RE: Starbucks and T-Mobile Lot 3B and 4A Krania Subdivision Grading and Drainage Plan Engineer's Stamp Date 2-23-2017 (File: K09D031C)

Planning Department Development & Building Services Division DRAINAGE AND TRANSPORTATION INFORMATION SHEET (REV 09/2015)

RE: Revised Grading Plan (K09-D031C) Starbucks and t-mobile Albuquerque, New Mexico

| | | LEGEND | | |
|-------------------------------------|----------------------------|---|-------------------------------|--|
| | | GRADING AN DRAINAGE PI | | 21645-LAYOUT-12-05-16 |

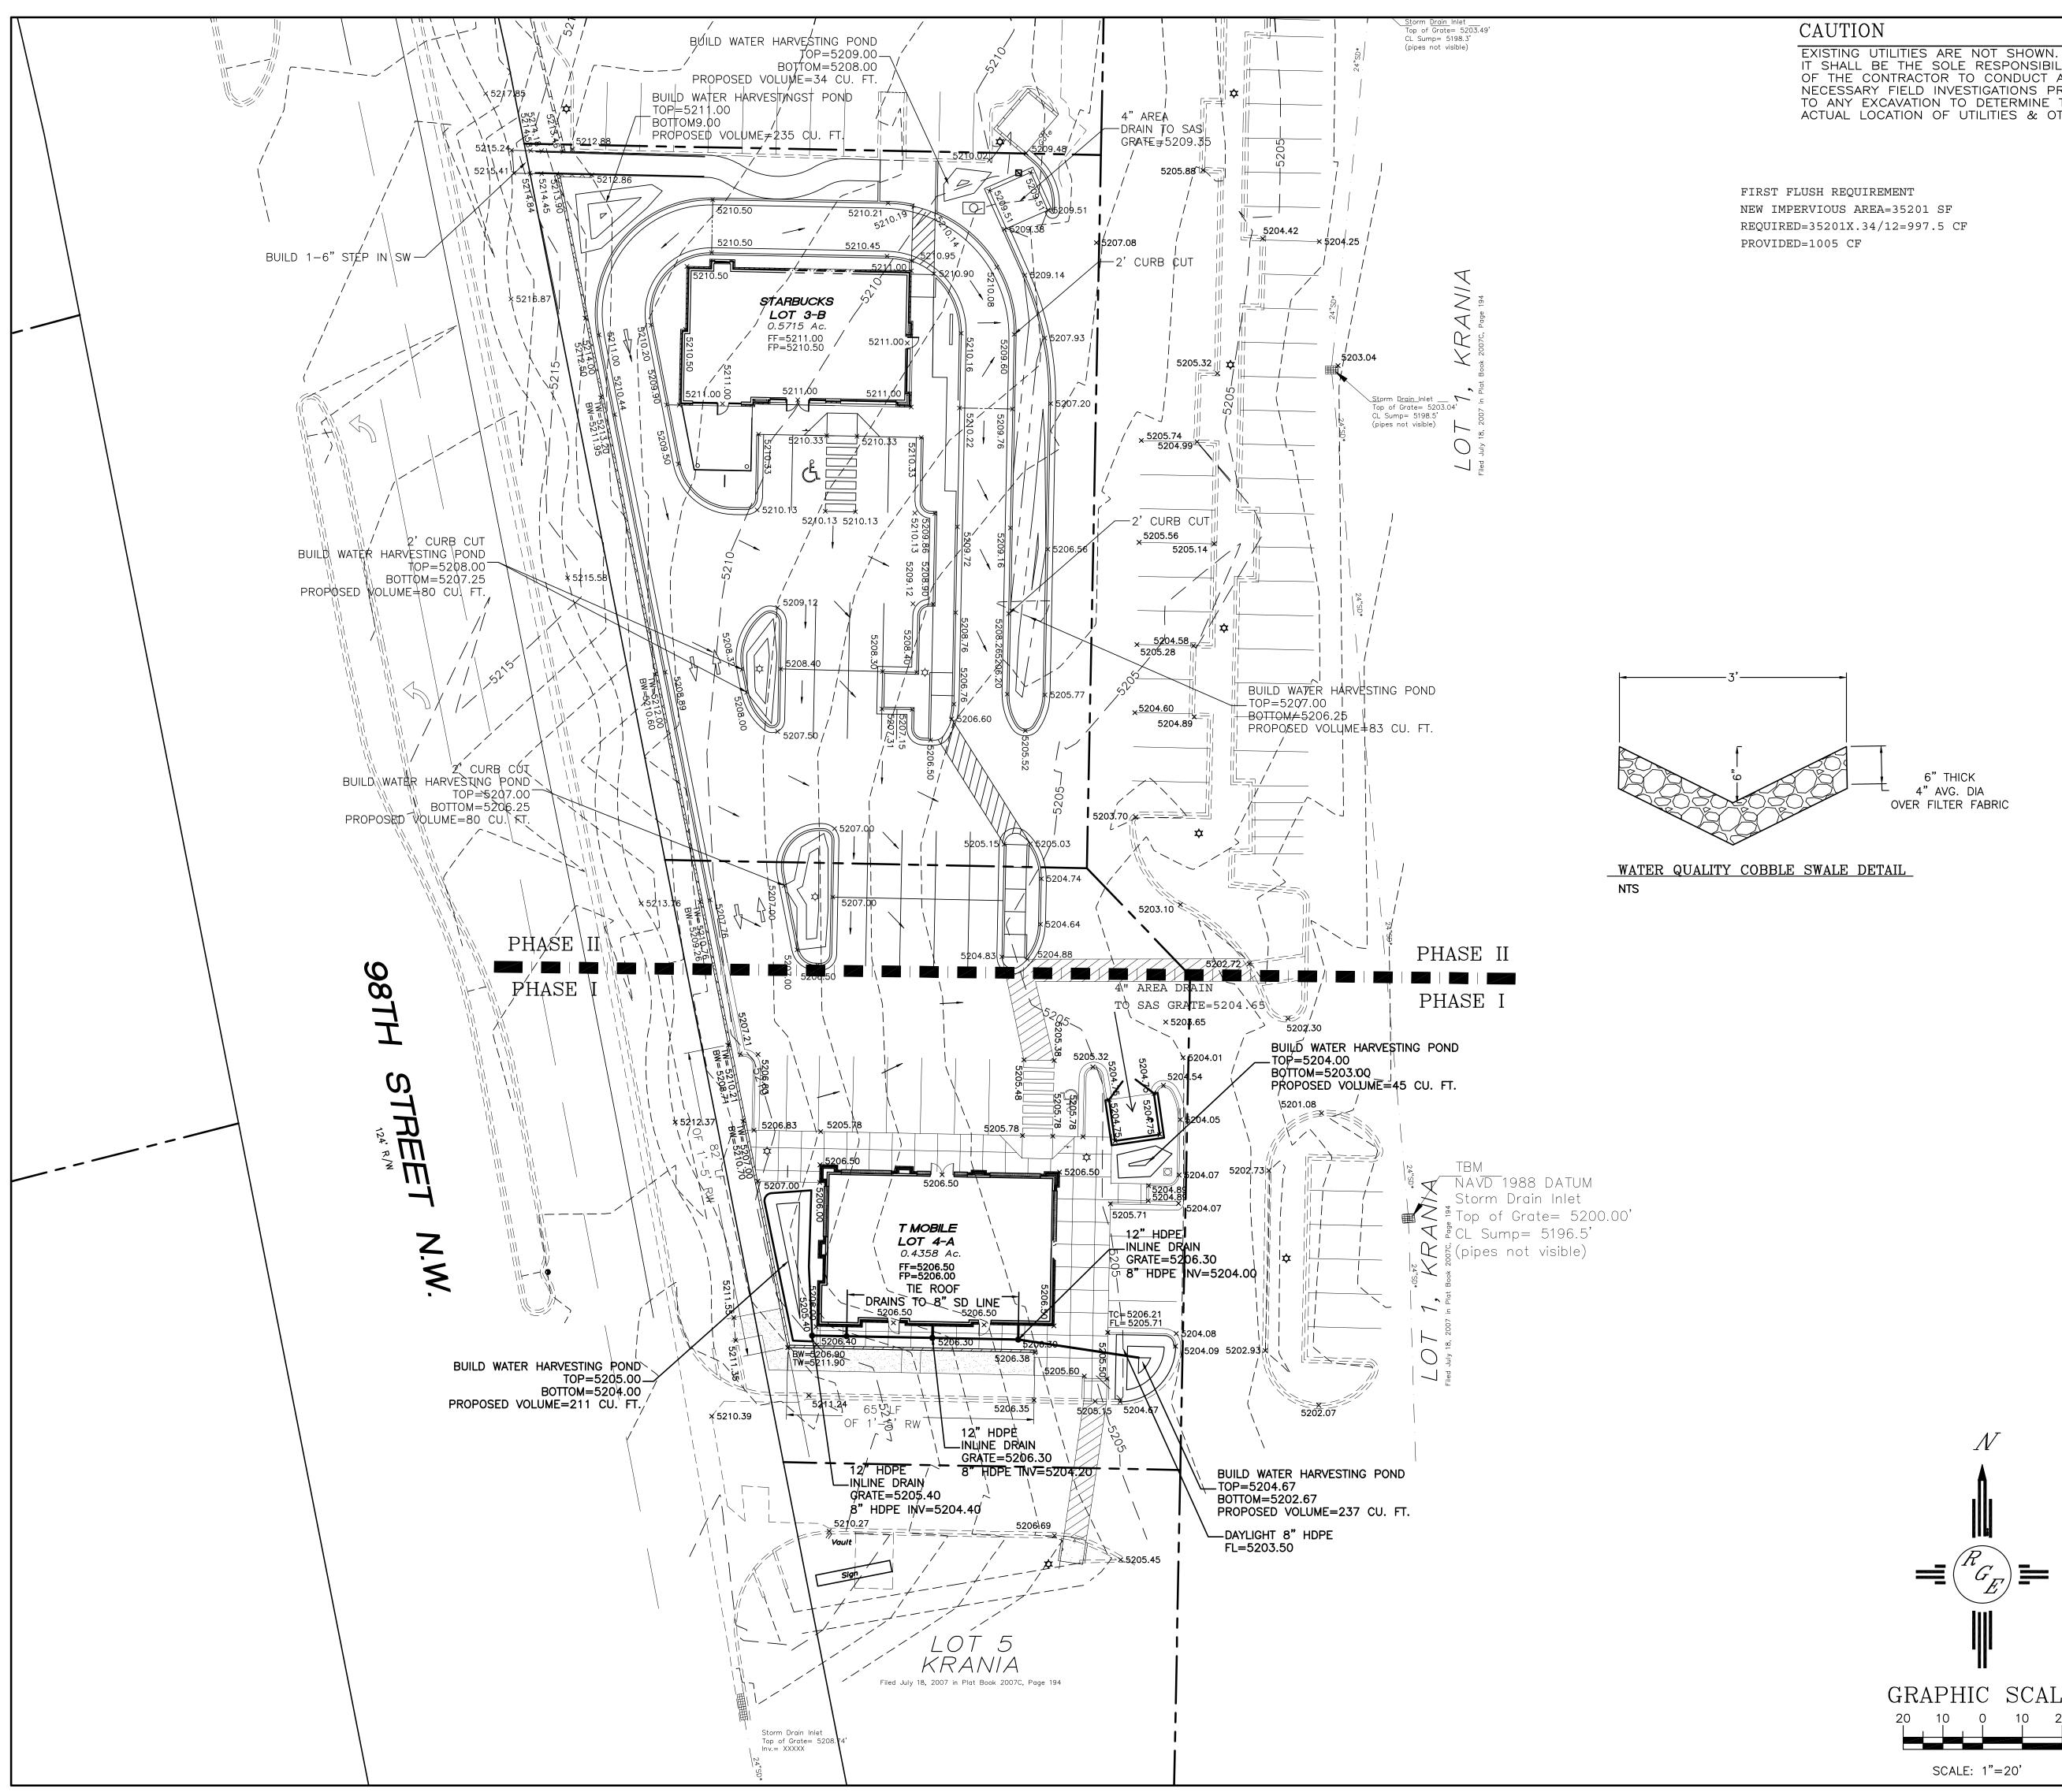
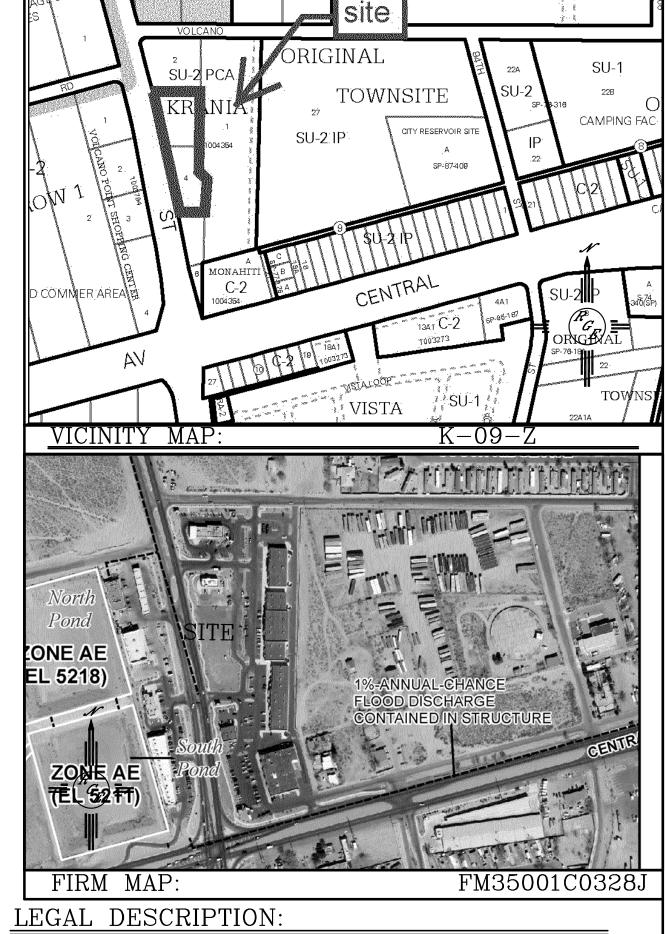
- 1. The drain must be extended to a grease trap and then to sanitary sewer system.
- 2. T-Mobile doesn't need area drain for trash enclosure.
- 3. Provide cross access and drainage easement. The survey provided doesn't provide the cross access of easement drainage. 4. Provide documentation allowing free discharge from this site.

1. Add grades and area drains in dumpster

2. Provide first flush calculations

3. Depress all landscaping included area behind dumpster.

4. Provide documentation on free discharge.

5. Show all easements

6. include BM

7. An ESC must be submitted prior to approval

We have added a spots and area drain to dumpster.

We have added the calculations to the sheet and attached spread sheet.

We have depressed landscaping.

This is a pad site of the Krania subdivision. The developed condition assumptions are located in File K09/D031.

We have enclosed an Alta that shows all easements

We have added.

An Esc should have been submitted by others.
